Cascades Leisure Centre, Gravesend Section 73 Application Landscape Statement Update

12th January 2026
Project no. 2333
GCLC-COL-XX-XX-T-L-0002-P03

Section 73 Application - Landscape Update

Landscape General Arrangement Plan - highlighting landscape changes

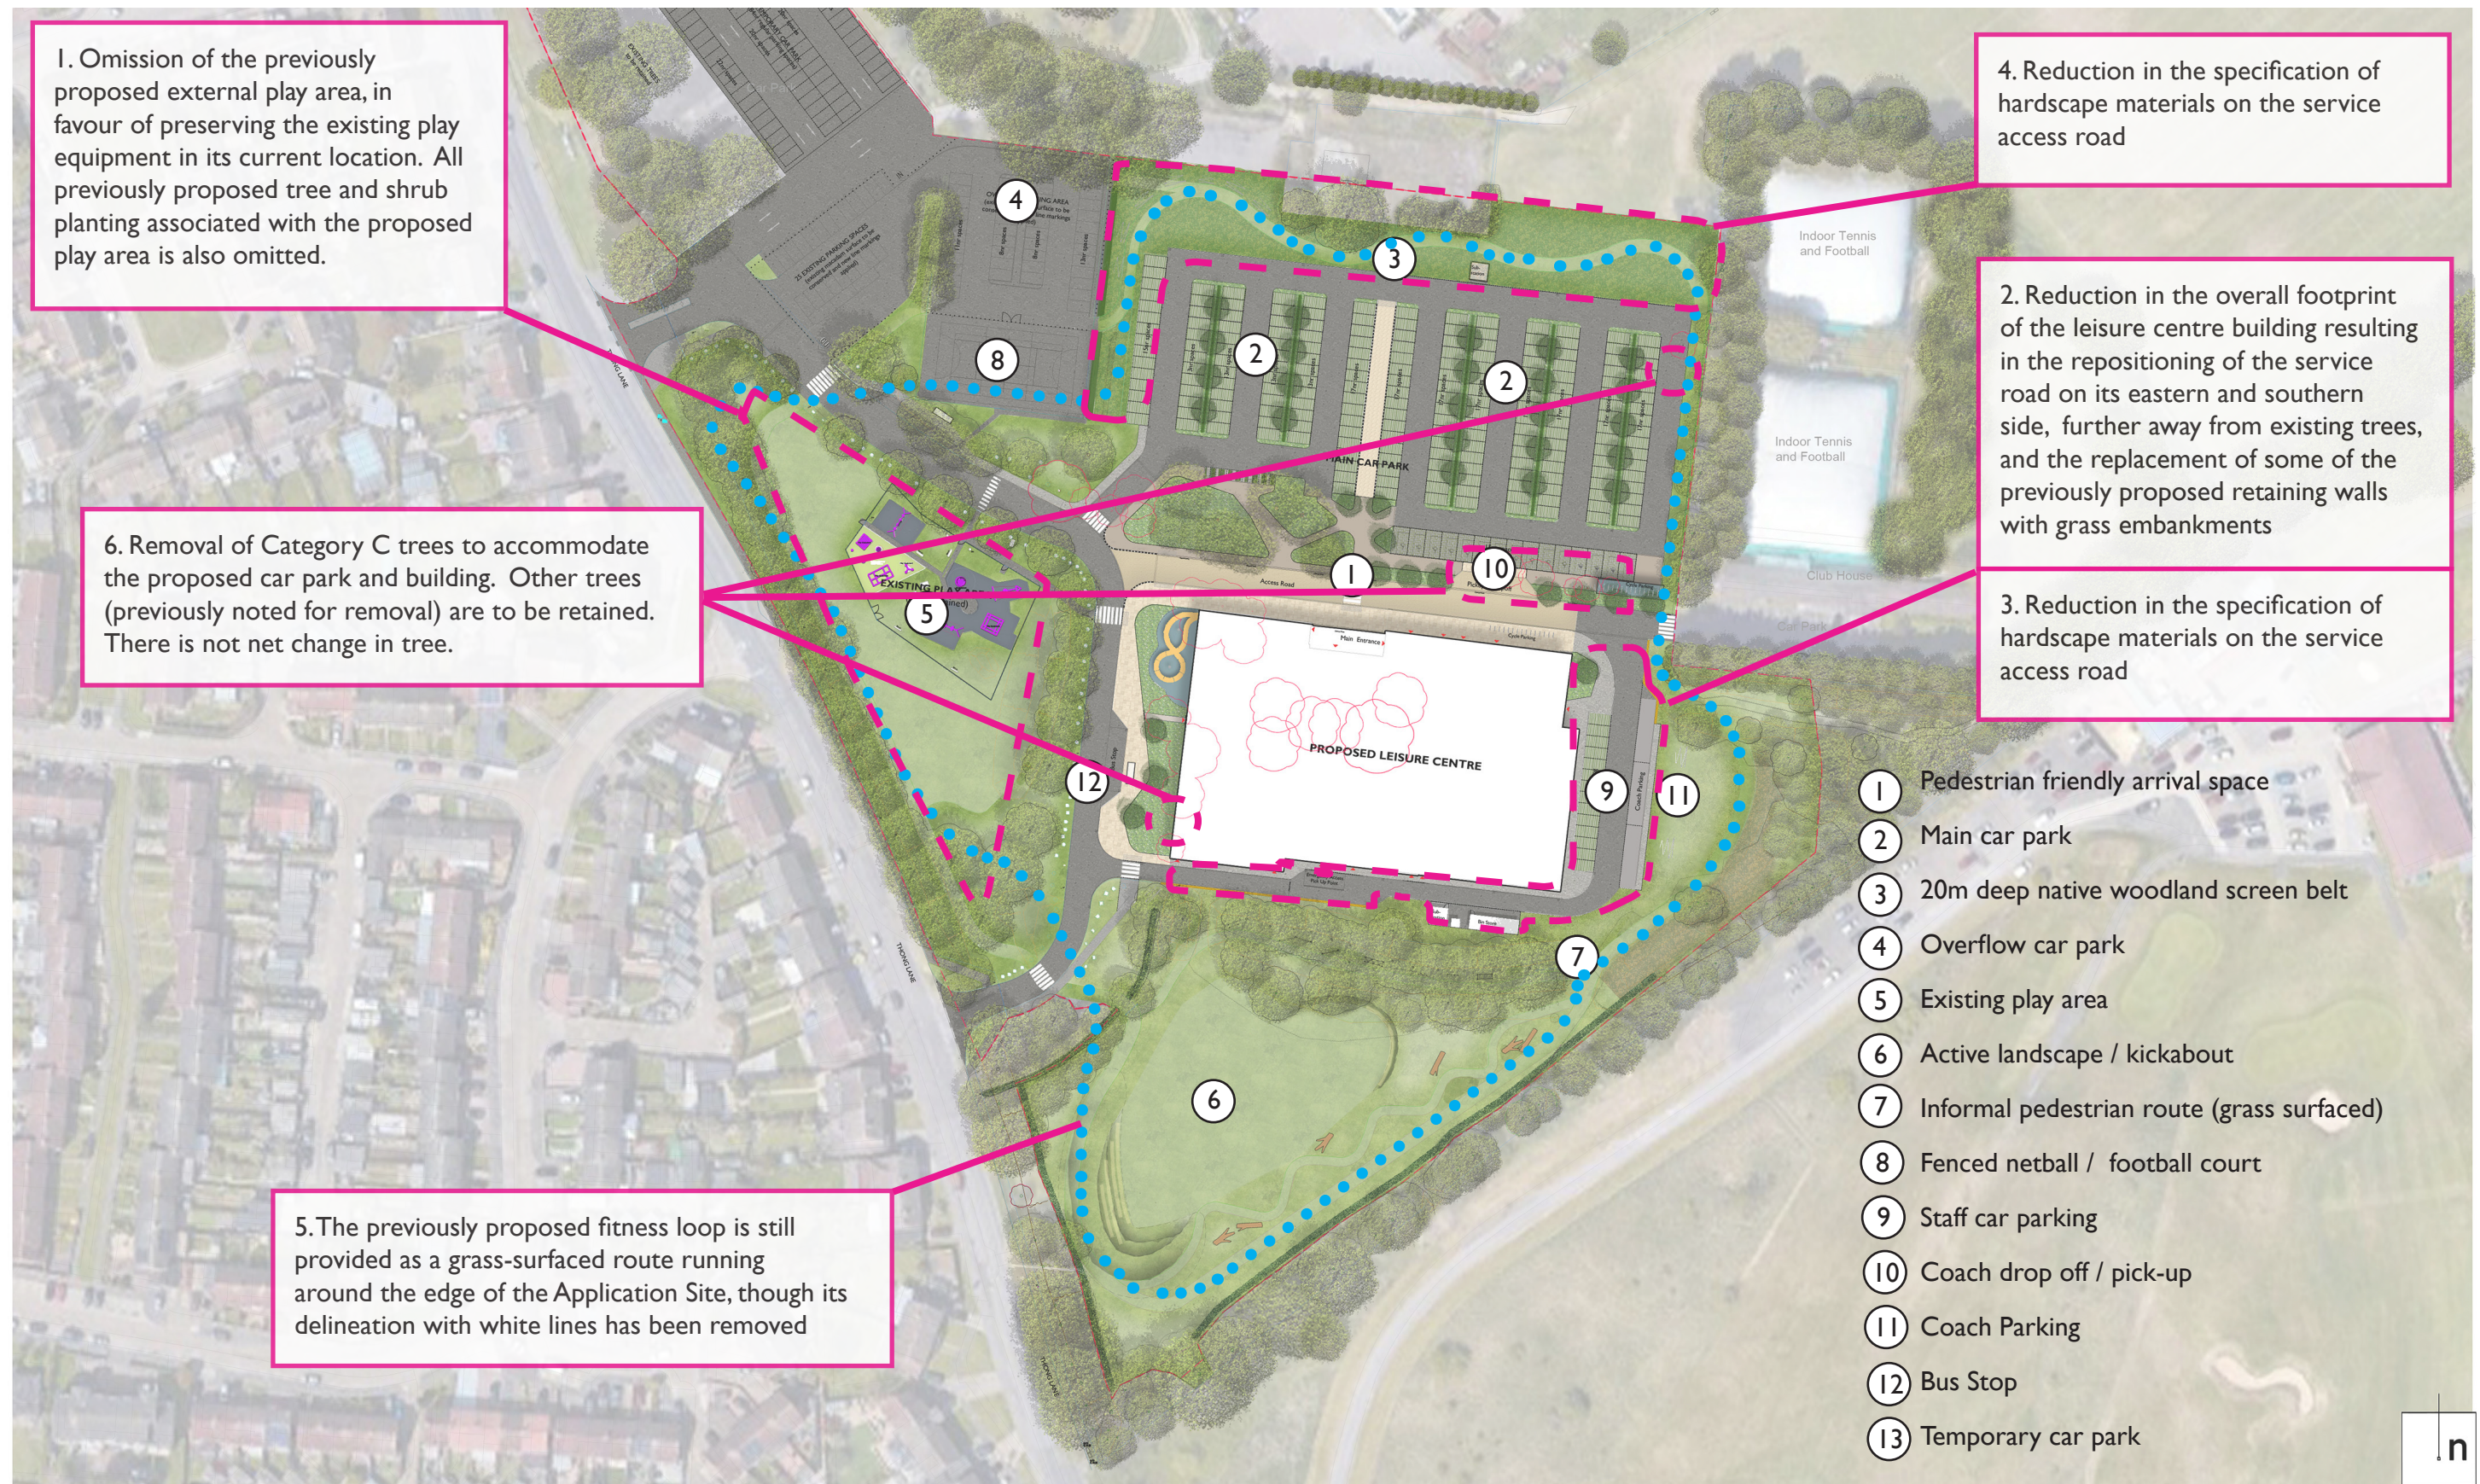
1. The main difference is the **omission of the previously proposed external play area, in favour of preserving the existing play equipment in its current location.** All previously proposed tree and shrub planting associated with the proposed play area is also omitted. These design changes, and associated cost saving, have been made possible by reconsidering the proposed location of the storm water storage facility which was previously proposed beneath the existing play area and, at the time, warranted its redesign.

2. The recent **reduction in the overall footprint of the proposed leisure centre building** has enabled the design team to move the service road and associated staff parking, coach parking, substation and bin store further away from existing trees on the eastern and southern sides of the proposed building. This has facilitated a reduction in the extent of the previously proposed retaining wall that dealt with the resulting level change between the service road and existing tree-lined embankment immediately to its south. Within the revised Section 73 scheme, the level changes between the existing Root Protection Areas (RPAs) and proposed service road are mostly dealt with via earth embankments (set at 1:3 outside RPAs), minimising the extent of proposed retaining walls. This represents a cost saving and preserves more of the existing landscape character than was achieved by the previous, planning-approved scheme.

3. Cost savings have been sort for both hard and soft landscape materials. **The specification of some areas of hardscape has therefore been reduced in certain specific areas.** Basic hardscape materials, comprising macadam roads and footways in lieu of block and slab paving, are now proposed around the “back-of-house” eastern and southern sides of the building.

4. In addition, the **tree planting specification has been reduced in size,** though not in number **for the proposed woodland mix** located in the more peripheral regions of the Application Site. This **includes the trees comprising the woodland mix proposed on the northern and western regions of the main car park,** as well as a few pockets elsewhere around the Site. However, tree planting proposed within the immediate curtilage of the proposed leisure centre building, including its main car park, remains as per the previous planning-approved scheme.

5. The previously proposed **fitness loop** is still provided as a grass-surfaced route running around the edge of the Application Site, though its delineation with white lines has been removed to save on cost.

6. The individual **trees that need to be removed** to accommodate the proposed development has changed a little, after re-reviewing the trees affected by the building footprint, car park, as well as the position of existing and proposed hard-paving relative to RPAs. However, there is no net loss in the number of existing trees that need to be removed, compared to the previous planning-approved scheme.

Tree Removal Strategy

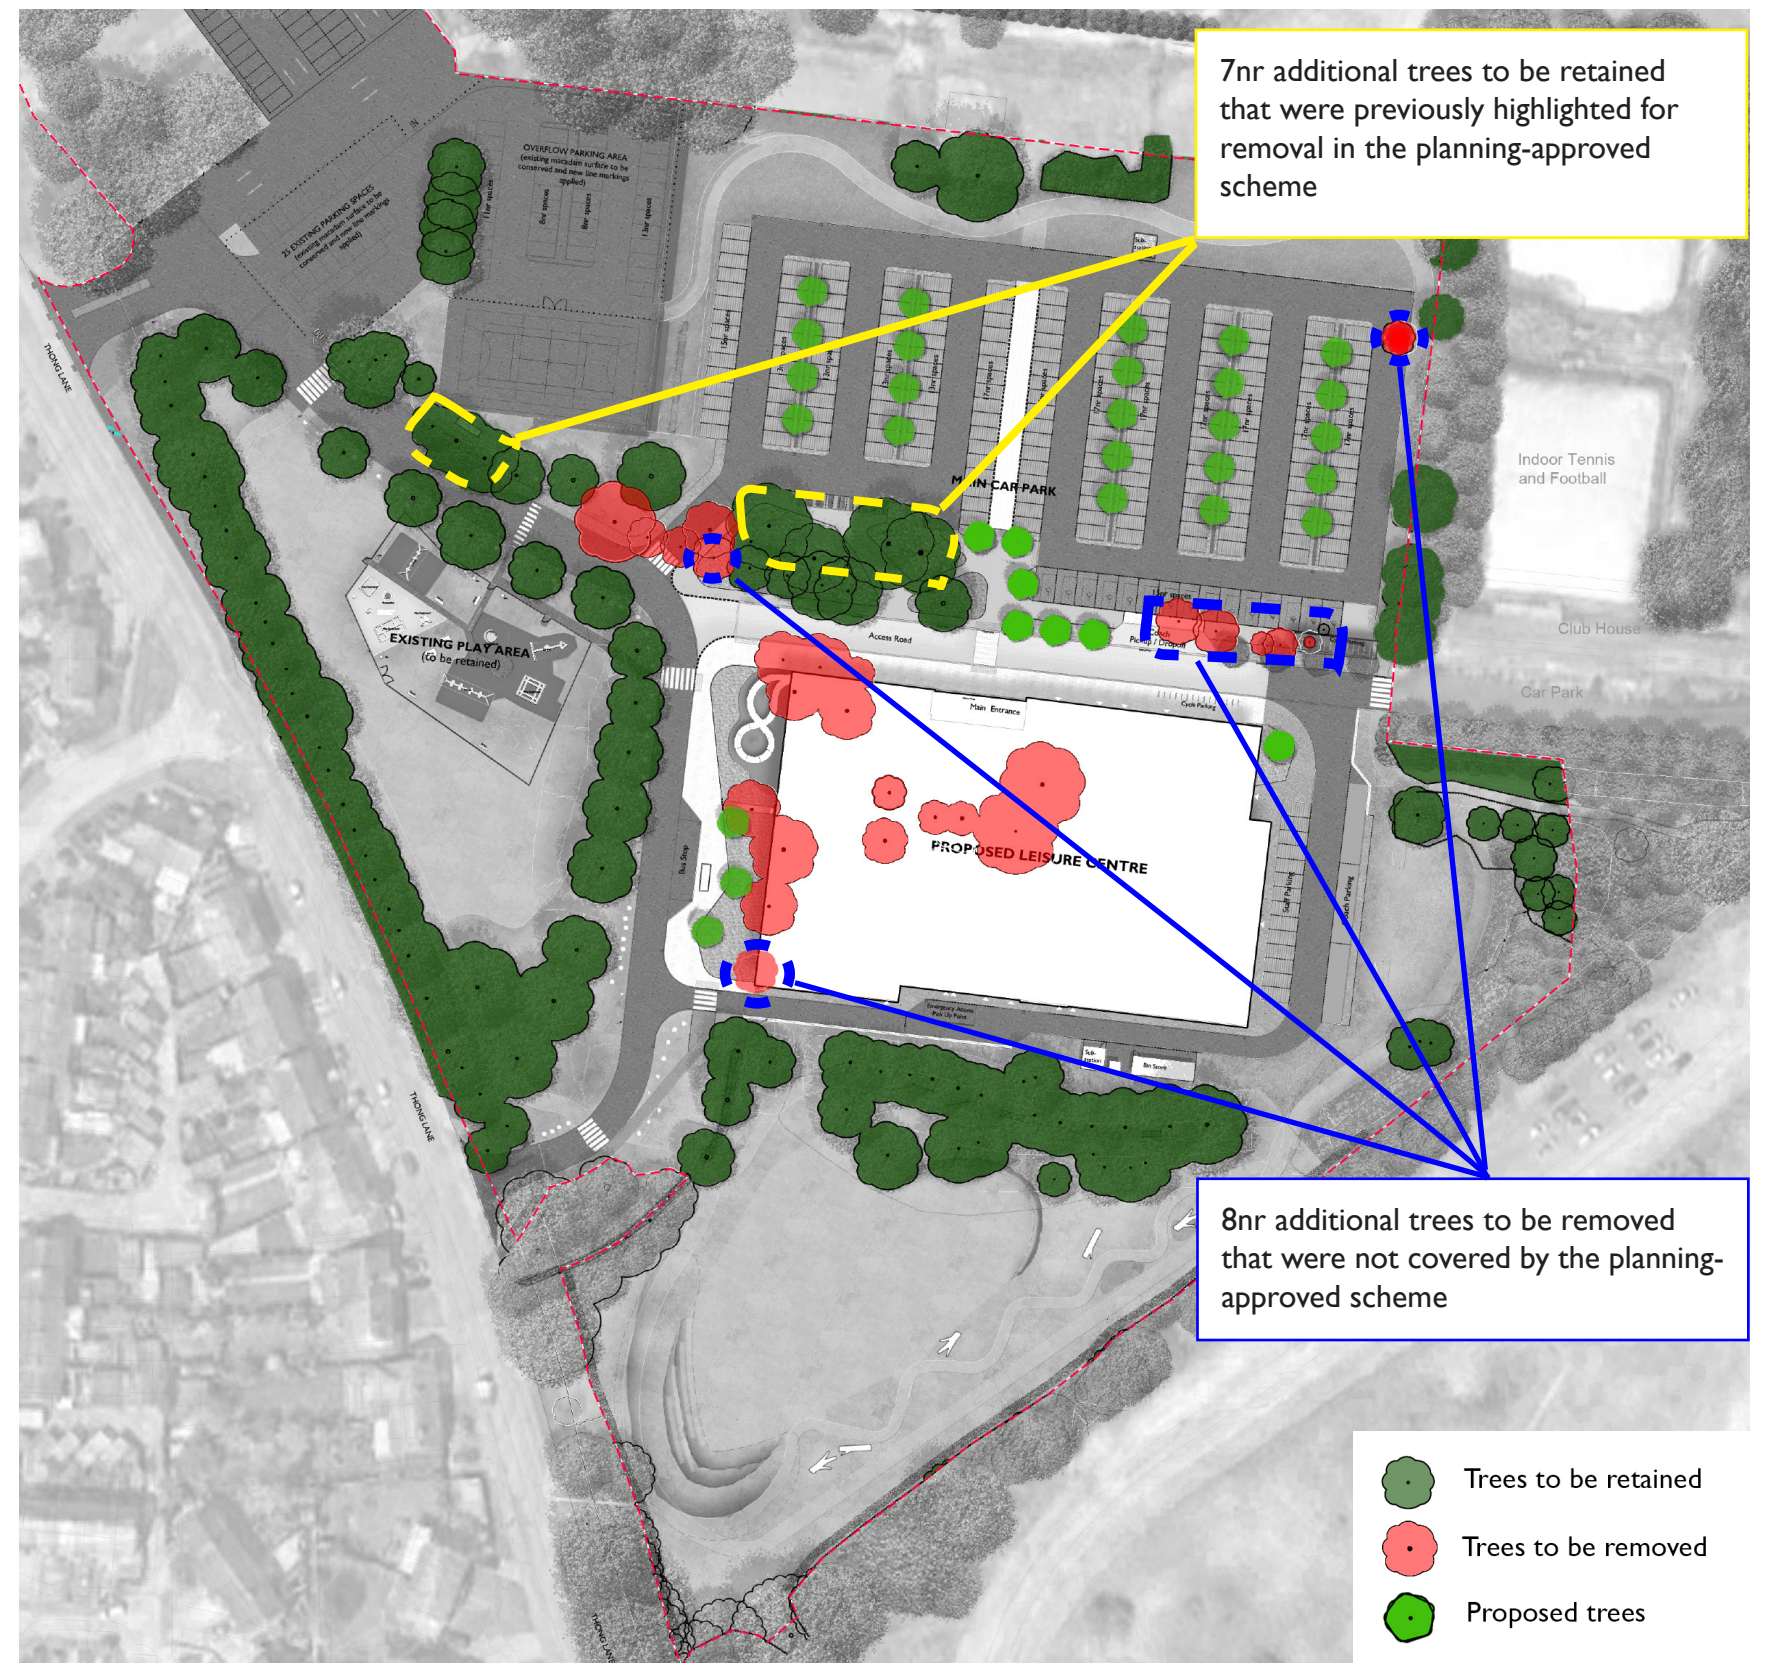
The tree removal strategy has been reviewed alongside the other changes comprising the Section 73 application. In so doing, some mistakes in the tree removal/retention diagram included within the previous planning-approved DAS have been identified.

Trees to be removed - this now includes 8nr Category C trees previously not identified for removal, comprising 1nr tree in the NW corner of the proposed car park, 5nr trees near the proposed disabled parking spaces, and 1nr tree located at the SW corner of the proposed building.

Trees to be retained - this now includes 7nr number Category C trees previously identified for removal, comprising 3nr trees on the northern side of the existing access road and 4nr trees just beyond the SW corner of the proposed car park. These trees can be retained because proposed hard-paving is designed to closely follow the routes of existing hard-paved areas, thereby minimising impacts on Root Protection Areas.

Note that small incursions of the proposed pavement into existing RPAs, which were previously surfaced with softlandscape, will be constructed in accordance with both BS5837 Trees in Relation to Design, Demolition and Construction, and the arboricultural consultant's Arboricultural Method Statement.

In summary, all trees that are to be removed are Category C and there is no net change in the total quantity to be removed compared with the planning-approved scheme.

17. Hardscape Materials

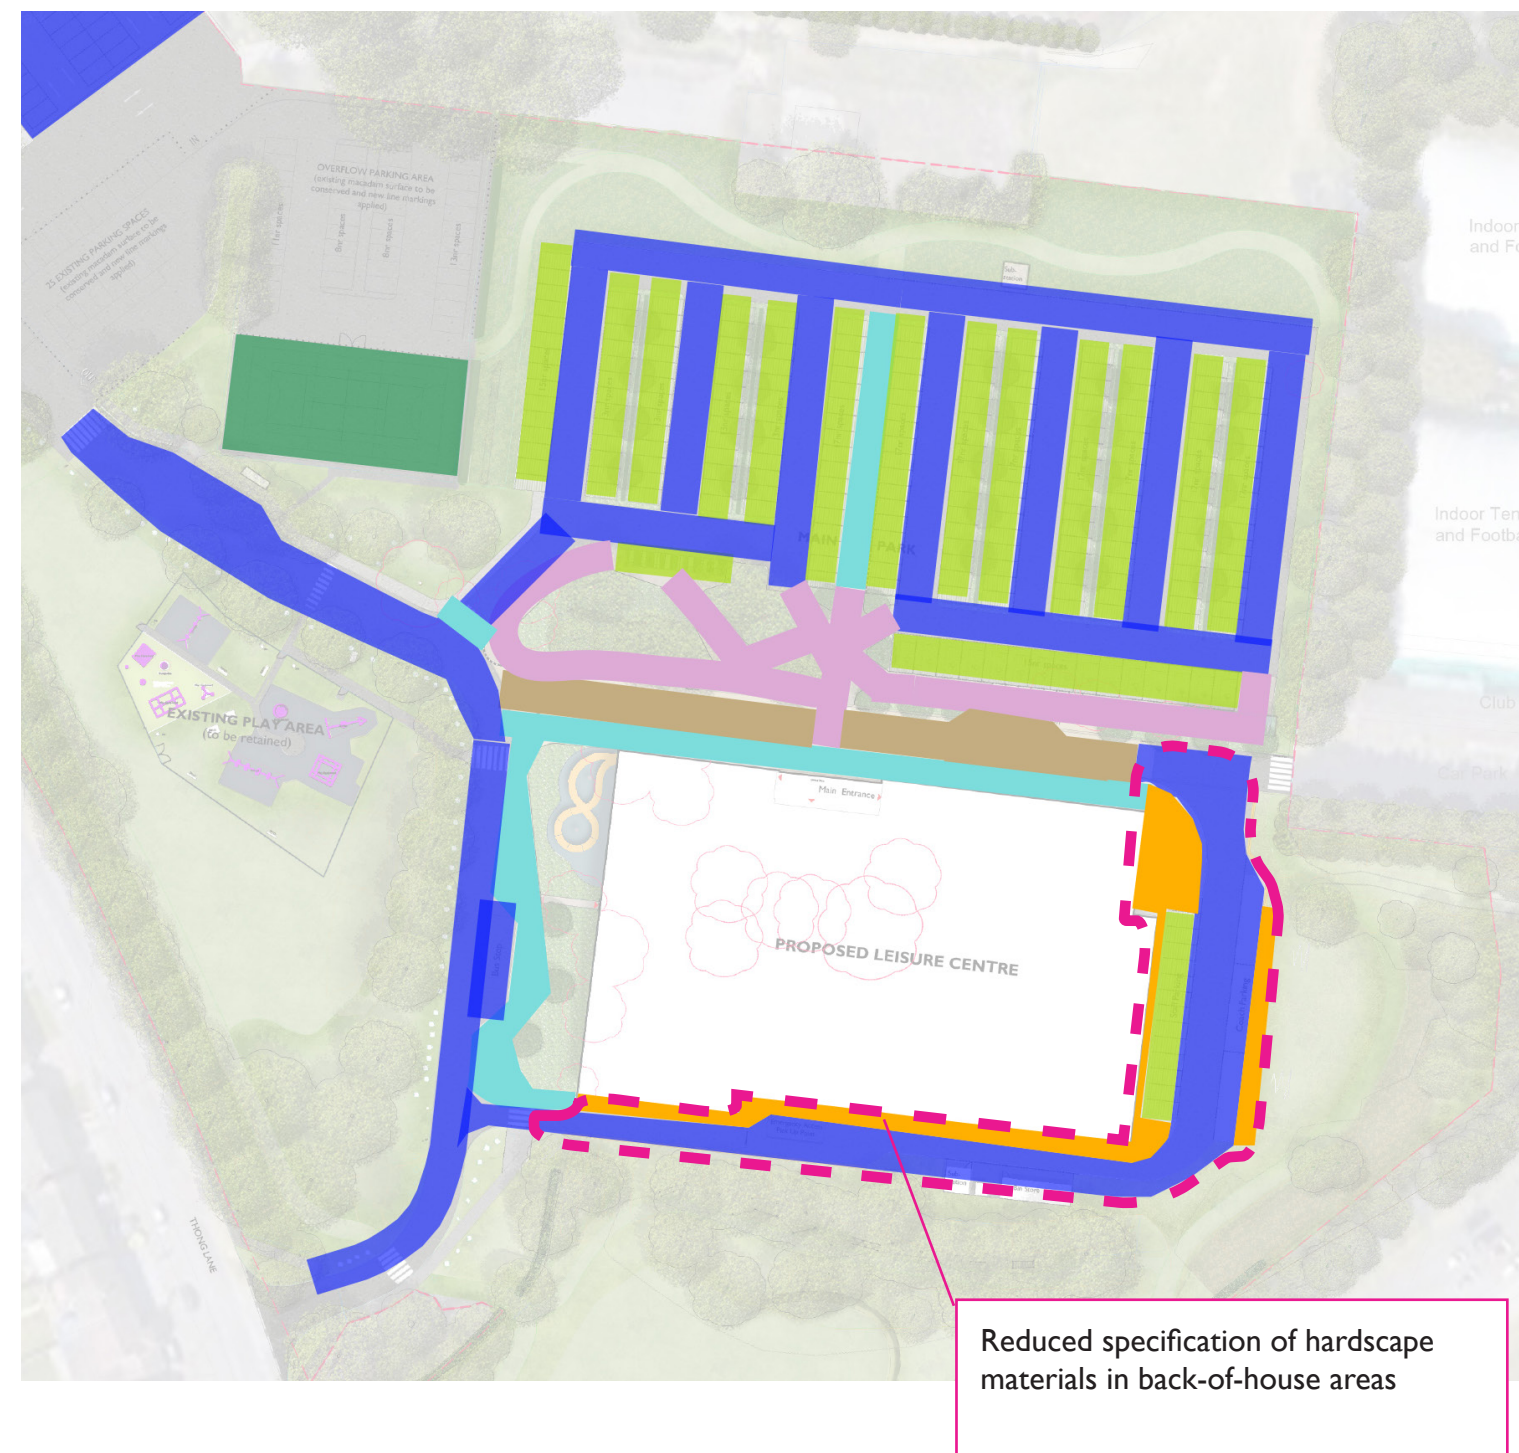
In order to reduce costs, the specification of hardscape materials has been reduced where possible, without compromising quality in key areas. The use of basic materials is limited to back-of-house areas located on the eastern and southern sides of the proposed leisure centre building, which have been changed from block paved carriageway and slab paved footways, to macadam surfaces in both instances.

Retaining walls that were previously proposed along the outer edge of this access road have been reduced in their extent, being replaced by grass embankments wherever possible.
